Product Change Notification: P-22-023500

Contact Male Gen-Y 0.64 Tab PIN_two new duplication production tools_it only support Asia-Pacific market currently

Explanation for two new duplication production tools 11-1961503&11-1961739 for Gen-Y TAB PIN

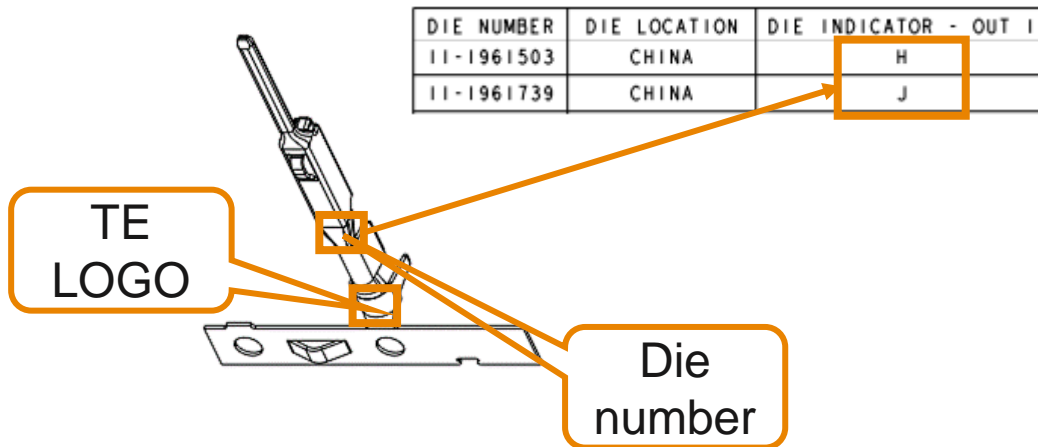
1. For China local customer requirement Gen-Y TAB PIN , the new duplication production tools (11-1961503&11-1961739) in TE Suzhou plant for production to support only Asia-Pacific market. For this new duplication production tools , it will shorten the L/T of delivery time and offer good service for Asia-Pacific market . EMEA customer do not need to change the China part , only keep original EMEA part
2. The identification of Suzhou production part is that there are die - identification marked “H” and “ J” TE logo on the part as below.
